**LEGAL ADVERTISEMENT
HISTORIC PRESERVATION BOARD
CITY OF PORTLAND**

**PUBLIC HEARING
392 SPRING STREET**

WORKSHOP
383 COMMERCIAL STREET

WORKSHOP
742 CONGRESS STREET

Woonerf Site Plan
383 Commercial Street

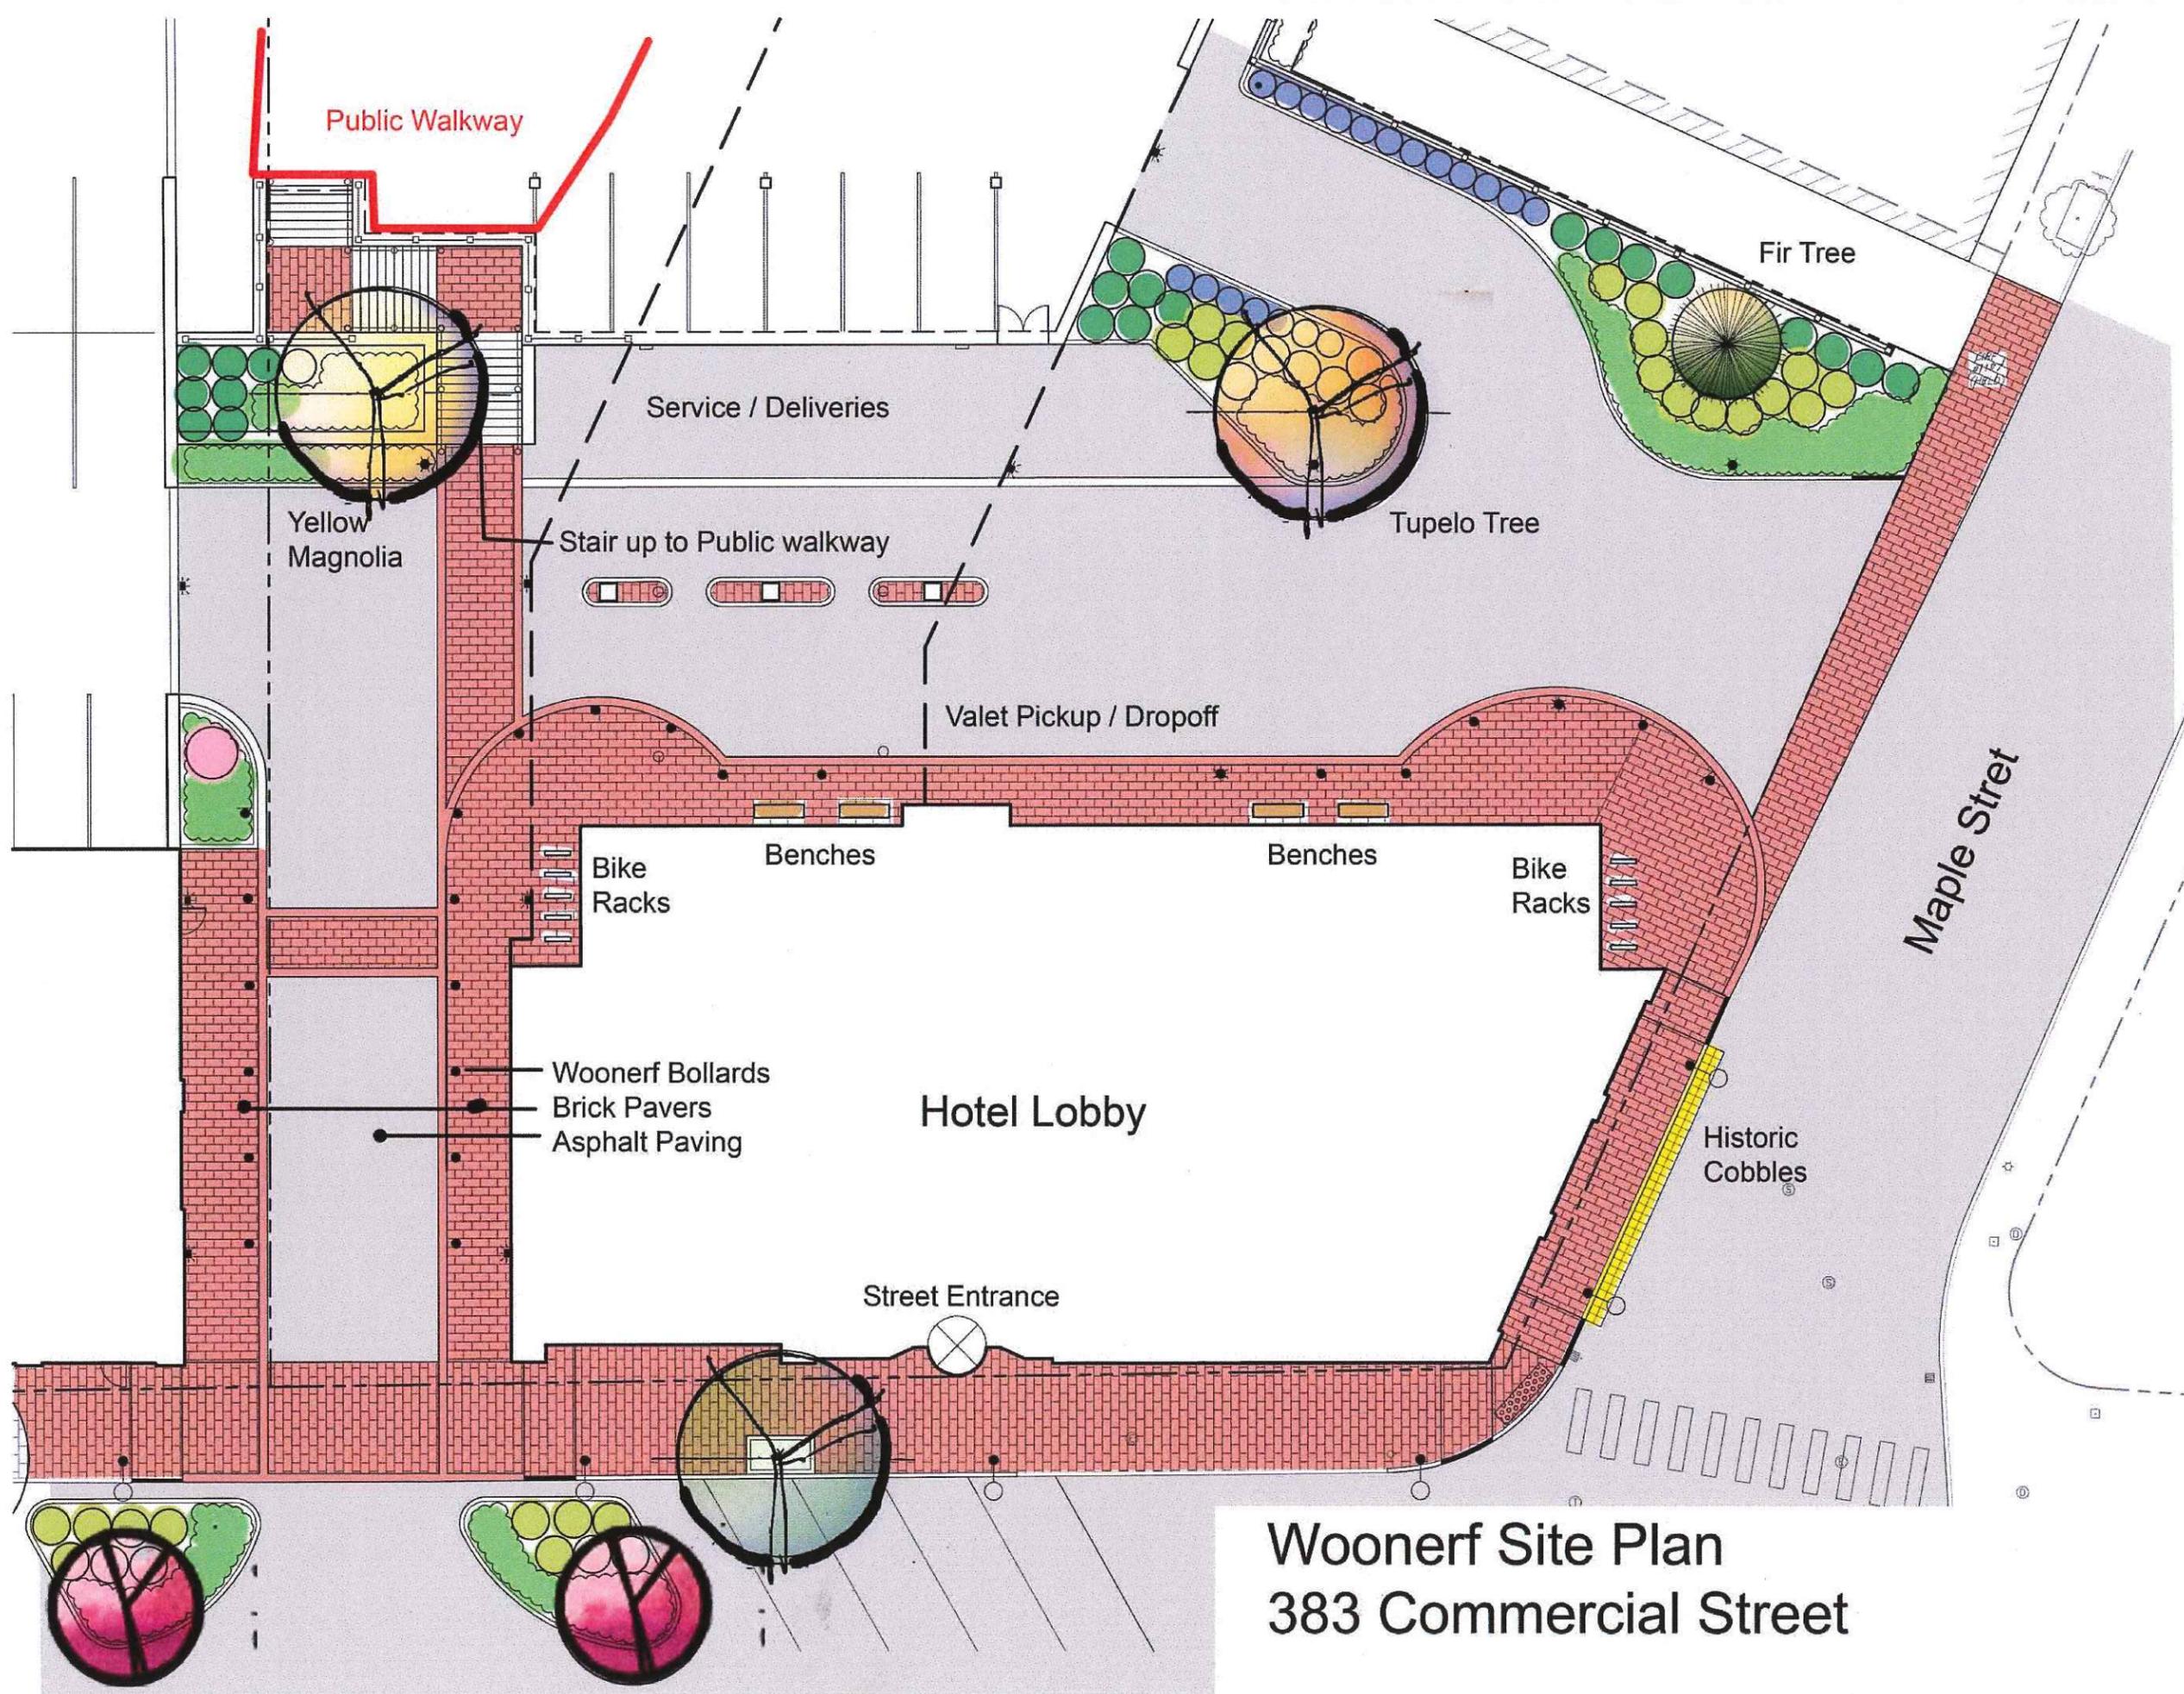
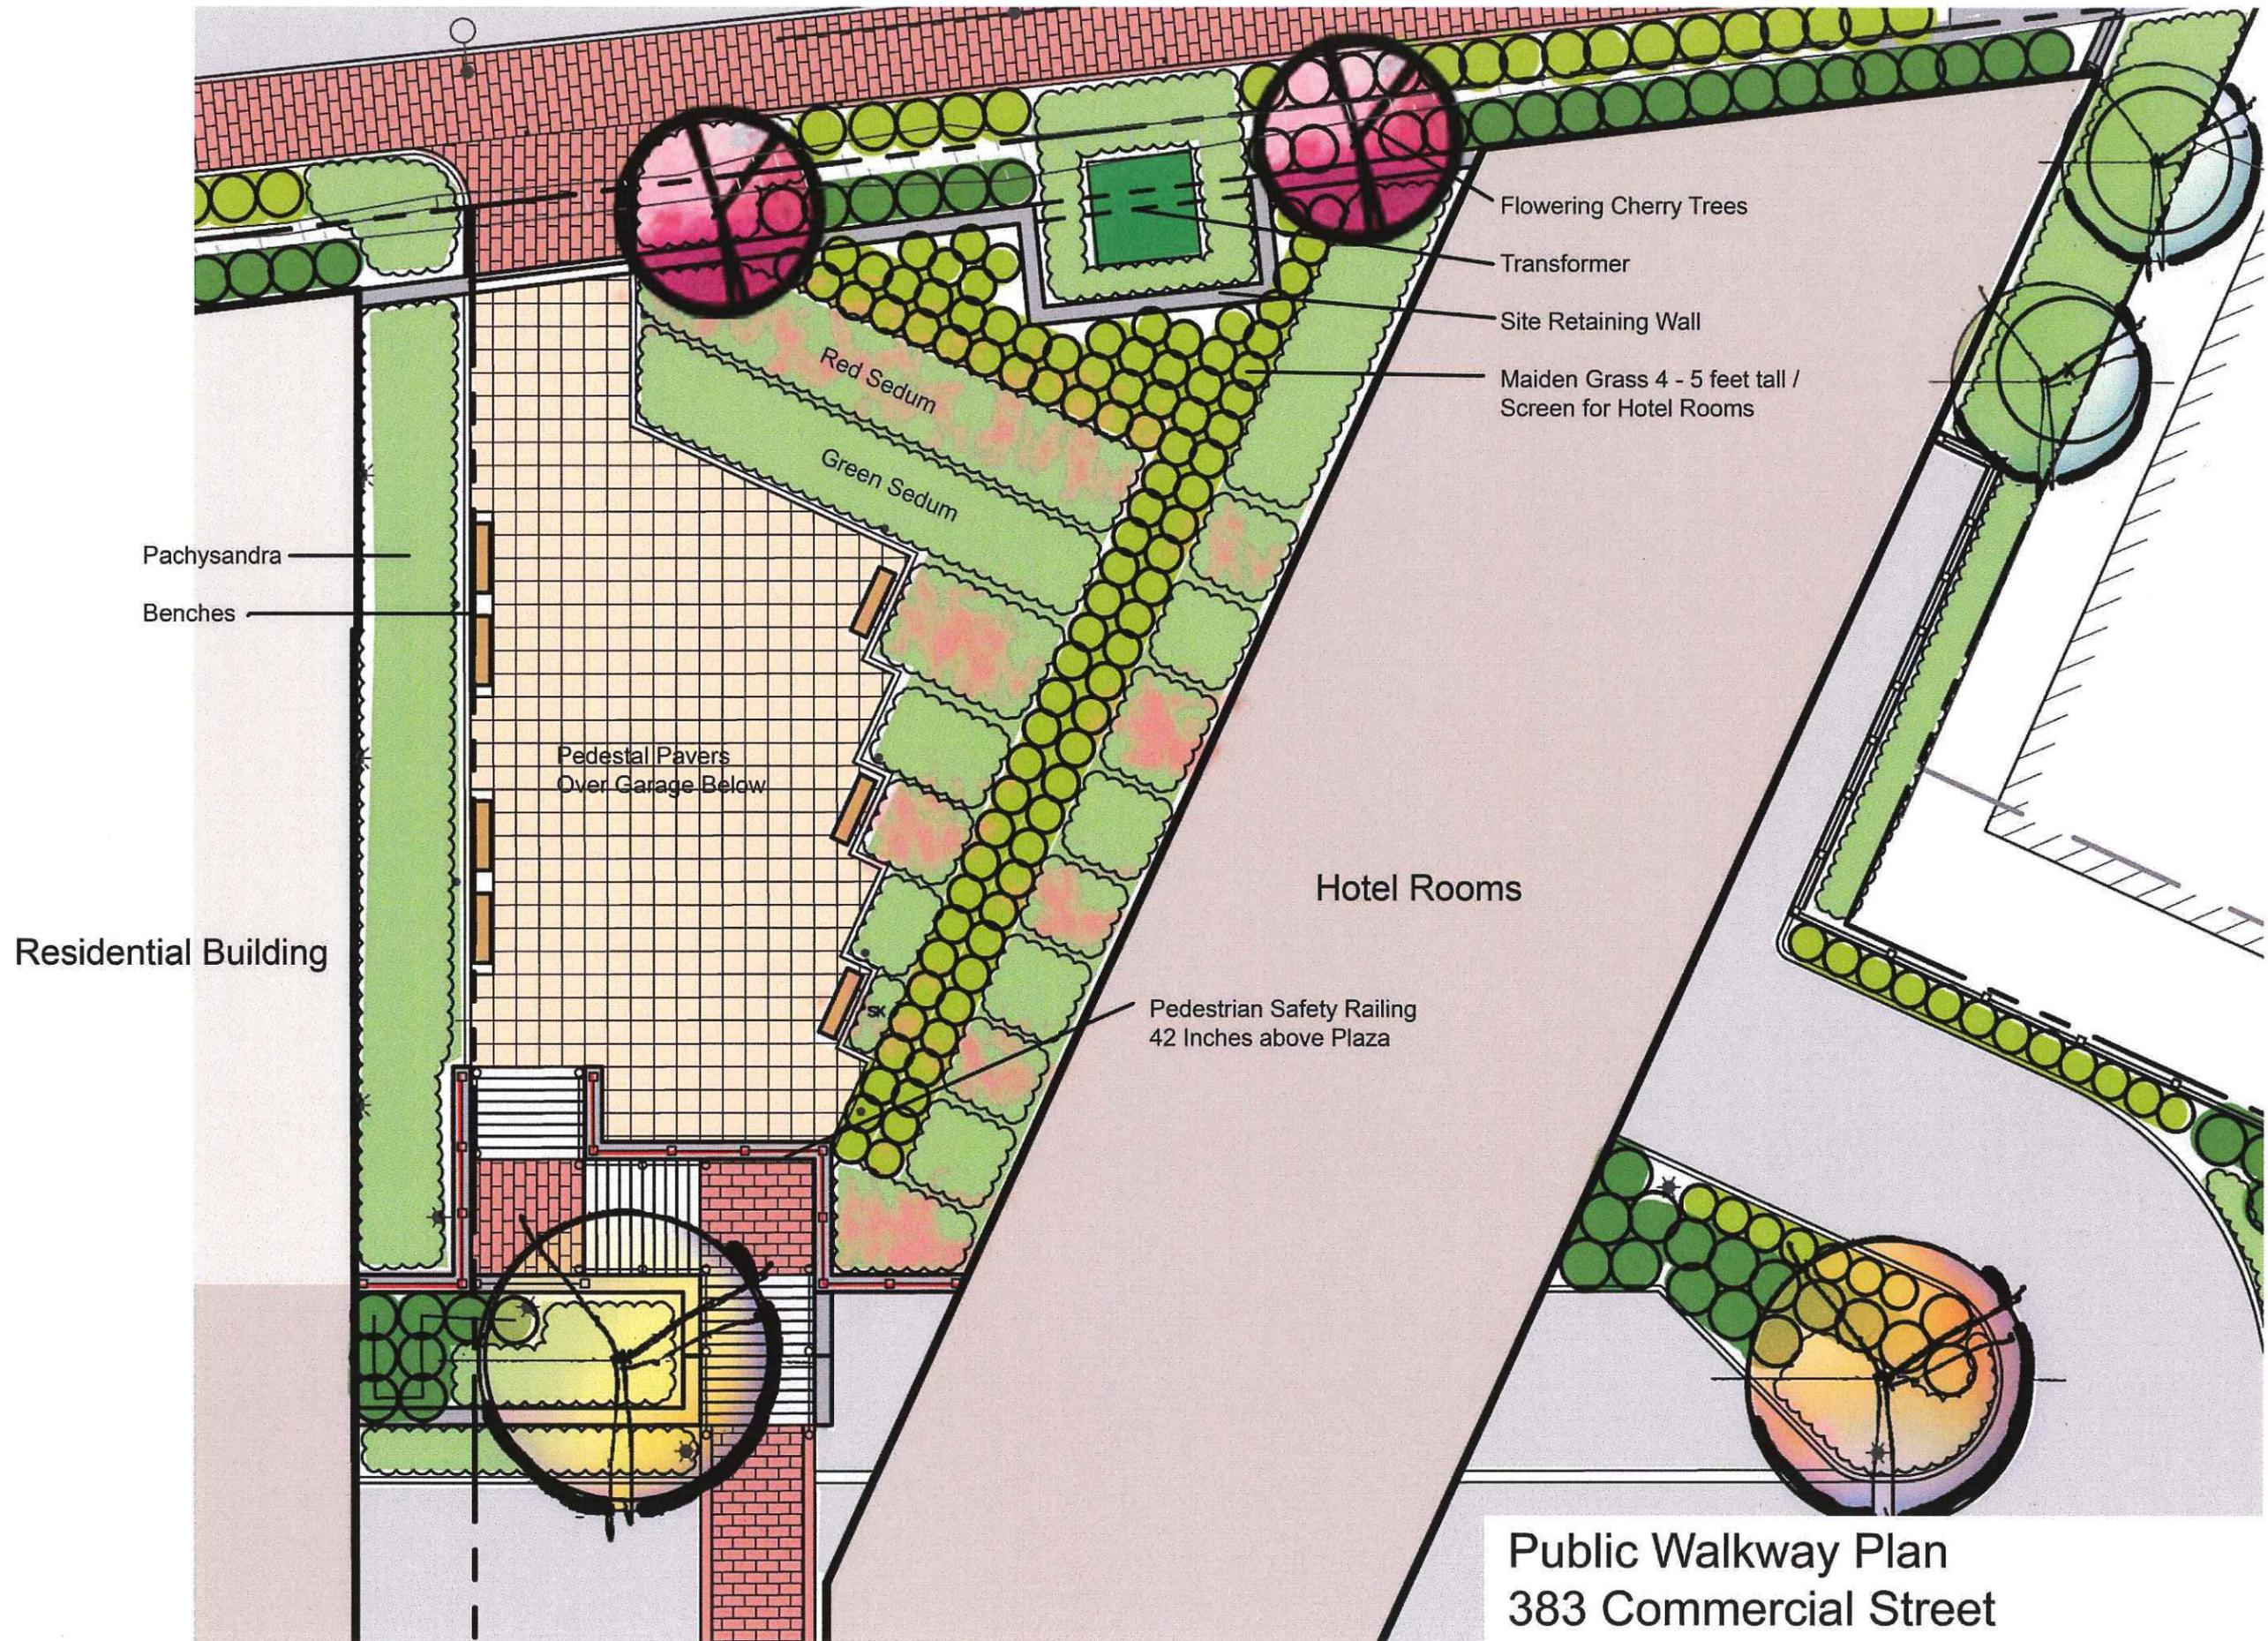
- As noted above, the bridge previously proposed to connect the residential development to the hotel has been eliminated.
- The submission includes a detailed site plan and renderings of the pedestrian passageway separating the two components of the development. Renderings of the passageway from both York Street and Commercial are provided. Note that the change in grade is accommodated by a set of steps and landings located well back from both frontages.
